NEWTOWN TO CITY TRANSITIONAL CYCLEWAY
30% DESIGN ROAD SAFETY AUDIT
PREPARED FOR WELLINGTON CITY COUNCIL
13 December 2021

30% Design Road Safety Audit

Figure 2-41: Proposed options for Vivian Street / Cambridge Terrace intersection

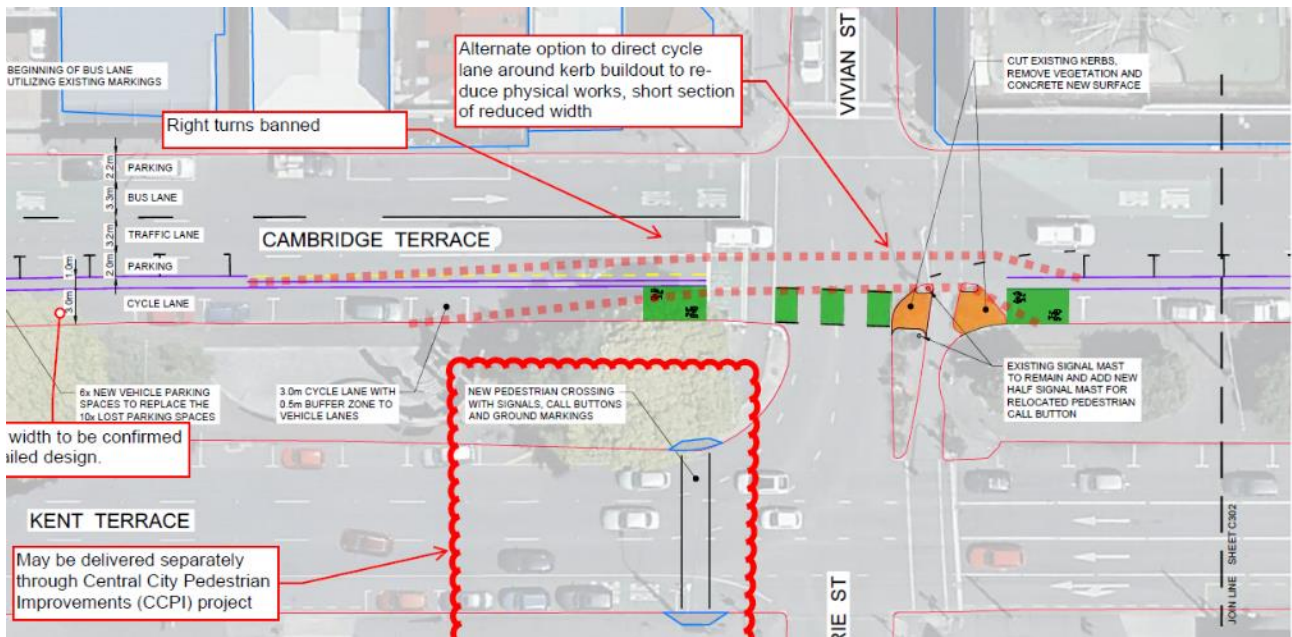
The SAT note that comment on the ban of the right turn from Cambridge Terrace, and through the central median to Pirie Street and onto Kent Terrace. The SAT acknowledge that the presented design is generally indicative of movement and will be developed further through the design process.

The SAT recommend that the intersection of Vivian Street and Cambridge Terrace / Kent Terrace be subject to a comprehensive redesign, to provide greater clarity of safe movement for all users.

Designer response	Further detail to be provided at 60% design. A separate pedestrian crossing facility is to be constructed by the Let's Get Wellington Moving programme in conjunction with the transitional cycleway programme.
Safety Engineer comment	Agree with SAT and Designer.
Client decision	Agree
Action taken	Updated in 90% design

Figure 2-42: Proposed Bus layover Area

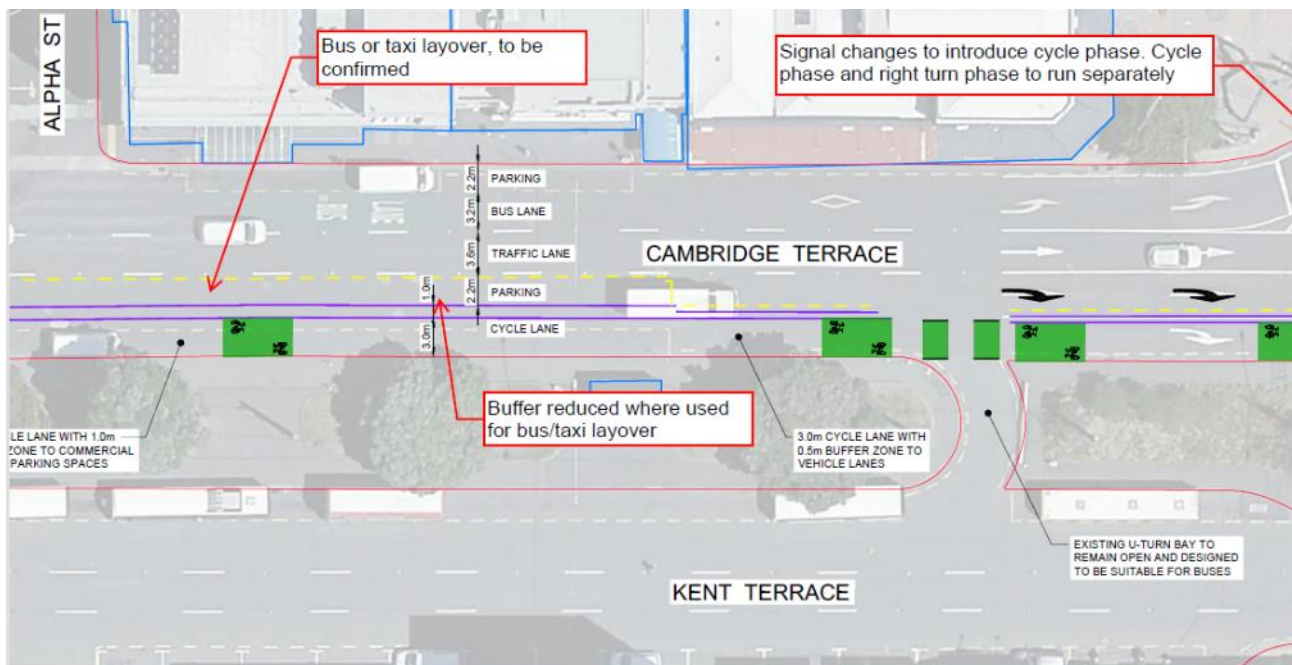
The proposed cycle facility along the central median will allow bi-directional cycle movements along the facility. This will require a high level of control on the nature and style of the facility over the U-Turn pocket as cyclists could not identify which channel the turning vehicle would use.

The SAT acknowledge that the bus layby will be utilised by regular drivers, and as such there is an effective mechanism to control driver behaviour through driver training and enforcement. The proposed design suggests incorporation of double lines to define the boundary between the park area, and the adjacent bi-directional cycle facility.

Frequency Crashes are likely to be occasional	Severity Death or serious injury is very likely	Rating The safety concern is significant
Designer response	Further design development is being undertaken in this area to understand the need for the turning facility and its relationship to the cycleway. If the turning facility is retained it will likely signed as bus-only and would include physical elements to supplement the paint markings and enhance safety for cycleway users.	
Safety Engineer comment	Agree with Designer and SAT.	
Client decision	U-turn pocket to be closed following approval by Metlink, with turning to occur as part of intersection phasing. Design including barriers to included in design updates	
Action taken	Changes as per client decision included in 90% designs

Figure 2-43: Proposed Courtenay Place / Cambridge Terrace design

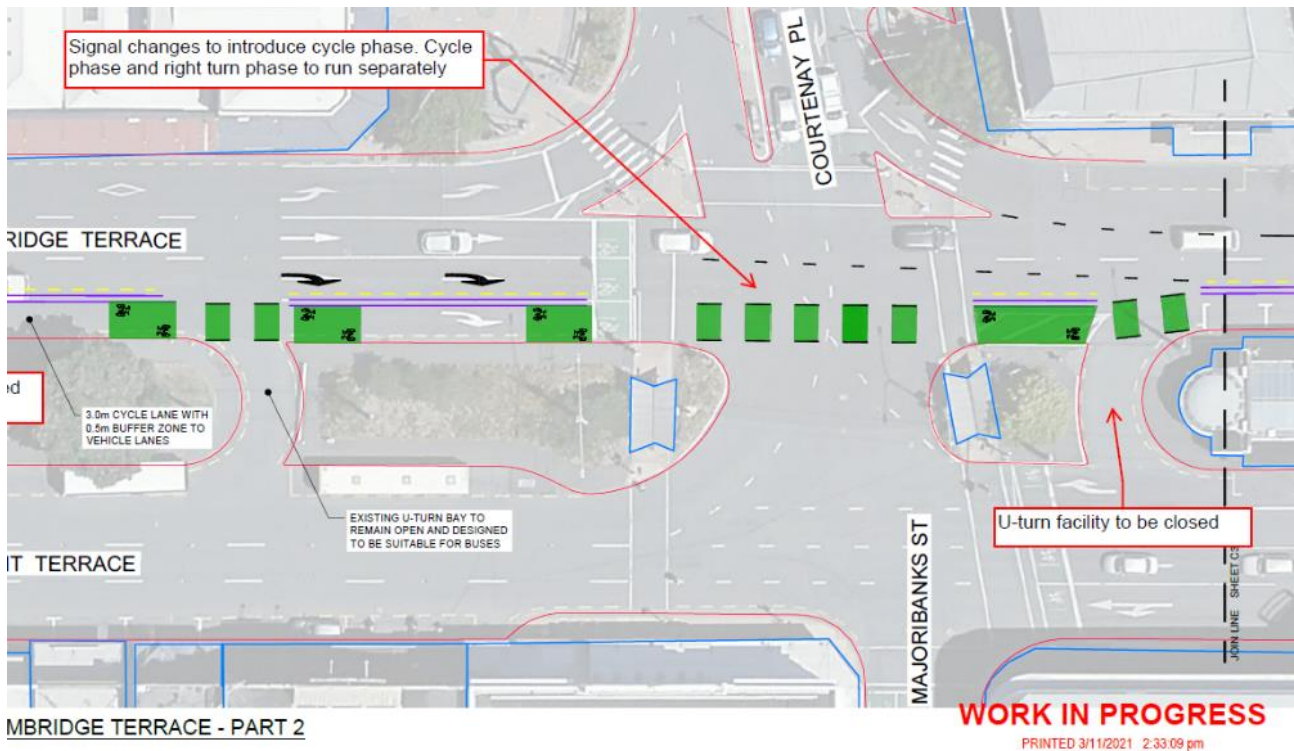
As with the Vivian Street intersection, the SAT consider that while the intent of the design identified the general through movement, it failed to consider the linkages to and from side roads, and suitable facilities across the central turn area.

2. The right turn phase should be separated to enable a safe crossing phase for cyclists (possible pedestrian phase as well?)
3. There is insufficient design detail for the cycle movement Cambridge Terrace (southbound) into Courtenay Place (part of the Golden Mile Project). This movement will be contrary to the permitted through movement on Cambridge Terrace.

Frequency Crashes are likely to be common	Severity Death or serious injury is likely	Rating The safety concern is significant
Designer response	The proposed route through this intersection is still being developed. The transitional cycleway will be constructed prior to the Golden Mile project. The cycleway should consider providing appropriate linkages to the adjacent network, however, the Golden Mile project will be responsible for connecting the proposed facility along Courtenay Place with the transitional cycleway.	
Safety Engineer comment	Agree with SAT and Designer. Throughout this project appropriate, safe linkages to the adjacent network must be considered.	
Client decision	Agreed As per response to Finding 2.1.8, Hook turn boxes to be considered for each intersection and provided where appropriate.	
Action taken	As per client decision

Figure 2-44: Proposed facility route – New World Corner

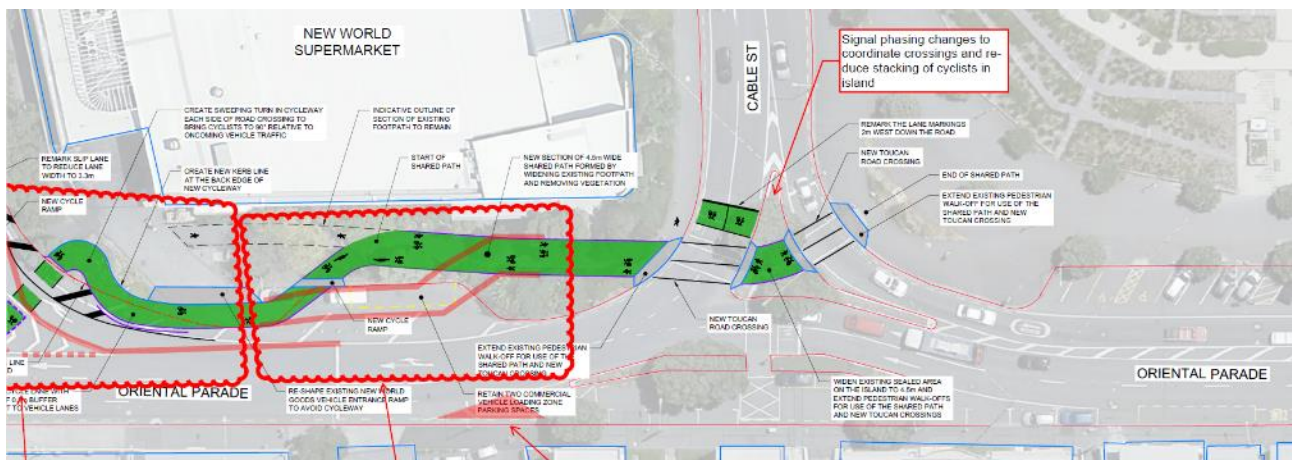
The linkage of the Oriental Parade / waterfront area is proposed to be formed as a shared crossing over Cable Street, leading onto a shared path along Oriental Parade, as shown in Figure 2-44 below.

The SAT generally agree with this design and consider that landing areas and signal controls will be developed to a higher level in future designs. In this matter we make no further comment.

Frequency Crashes are likely to be infrequent	Severity Death or serious injury is unlikely	Rating The safety concern is minor
Designer response	Further development of the route through this section is being undertaken and will be included in the 60% designs.	
Safety Engineer comment	Agree with SAT and Designer	
Client decision	Agree	
Action taken	Further design completed for 90% RSA

Figure 2-49: Proposed alignment – New World back of house

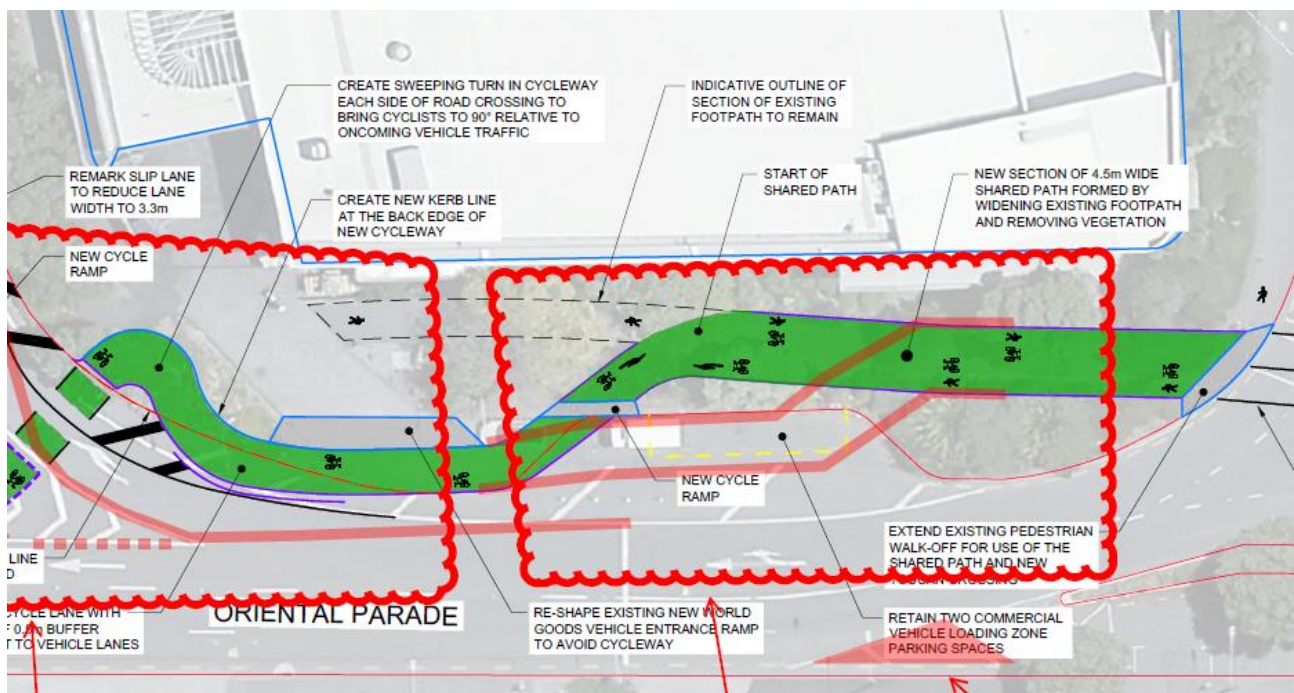
The proposed new facility design is significantly impacted by this operation, with the proposed facility occupying the current loading zone.

Movement in this area, and the new facility design is significantly compromised by the vertical change in levels between the current footpath and the road surface. In addition, significant underground utility structures are present in the gardens to the south of the New World loading dock access.

Figure 2-51: Proposed options for New World Corner

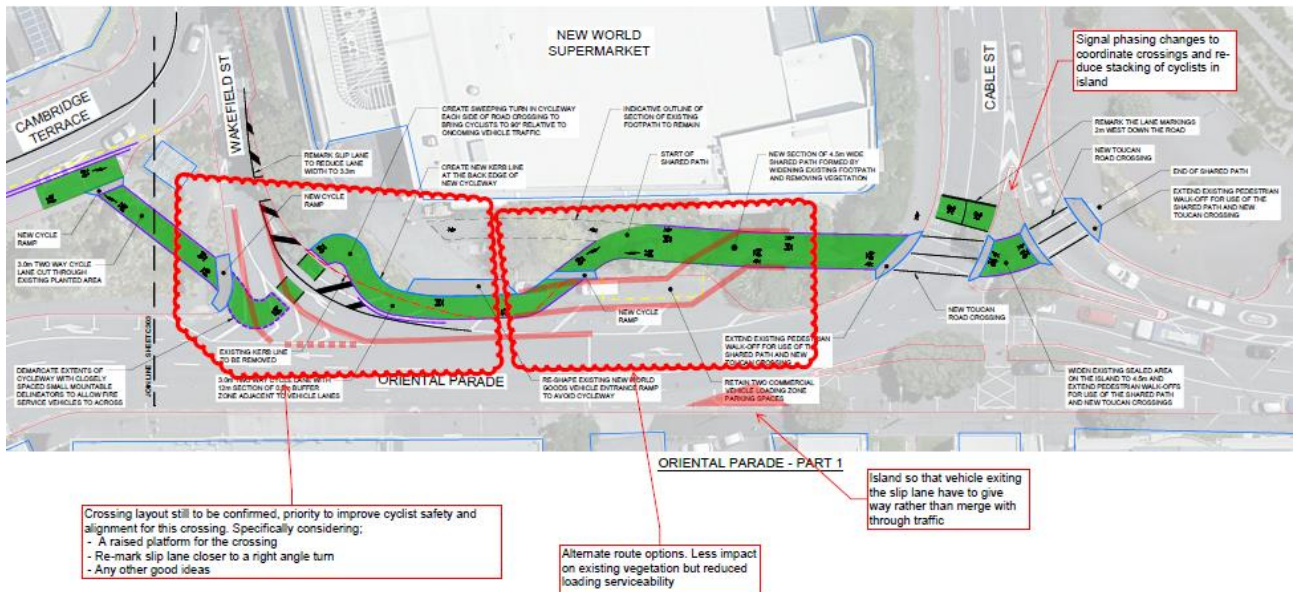
It is the opinion of the auditors that the **combined effects of all the issues** raised below result in a rating that would be considered **SIGNIFICANT** to **SERIOUS**.

The SAT acknowledge that one option has the proposed crossing point reorientated and relocated closer to Oriental Parade, as detailed in Figure 2-51 above.

Of significant note to this crossing point is the observational characteristics of cycle users. In the current alignment they are required (westbound movement) to negotiate a downhill grade, through a series of curved alignments, and at the same time observe and react to faster moving vehicles traversing around the right hand turn at speed. The proposed new alignment option (green surface, Figure 2-51) would require a cycle user to traverse through an even tighter curve. The design does not identify what would be the intent of vertical grade. See also Section 2.7.3.

Figure 2-56: Proposed alignment options

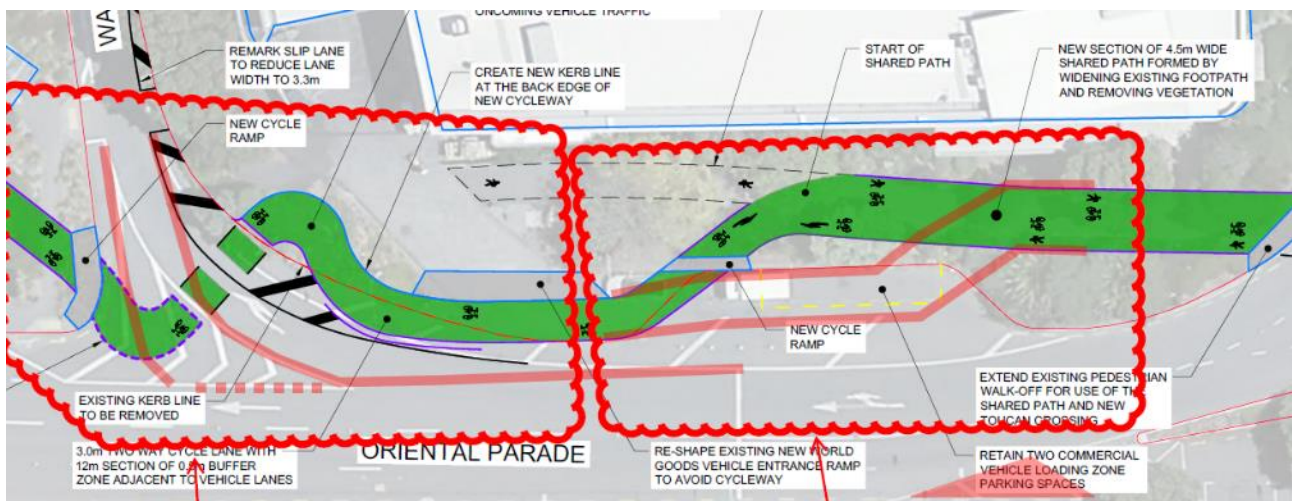
A key design element for consideration of any new facility is the effect that the existing topography will have on the safe movement of shared path users.

All options require the users to traverse from the existing path alongside the rear of the New World supermarket, down to the existing road surface level. This height differential appears to be in the order of 1.2 to 1.5 metres.

Figure 2-64: Possible alternate route

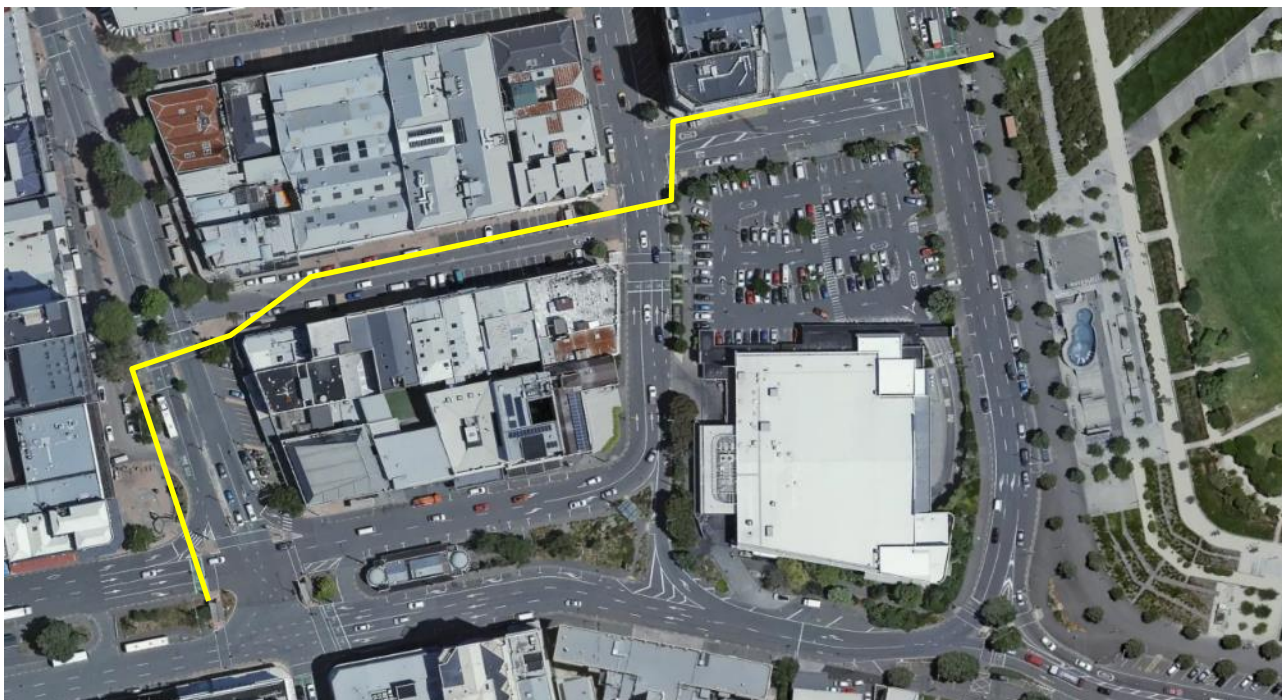
Considering that this connection will lead the commuter cyclist wanting to access the CBD, the SAT have considered utilising this connection and then providing linkage via the signals at Blair Street to connect through the calmer side streets, to the waterfront. An outline of the route is demonstrated in Figure 2-64 below. This route would allow use of slow streets, fit to a desire of engagement to the side roads, and utilises existing crossing infrastructure. Slower side roads could be utilised as greenway style treatments with urban form that would encourage slow driving.

The SAT acknowledge that there would be challenges along this alignment, and would require careful consideration of impacts on business and parking, along with changes to signal operation etc.

An alternate alignment such as this eliminates the risk of expensive treatments and design at the New World corner, and encourages users to an area where there is more amenity and associated business (café etc) offering better connection to business.
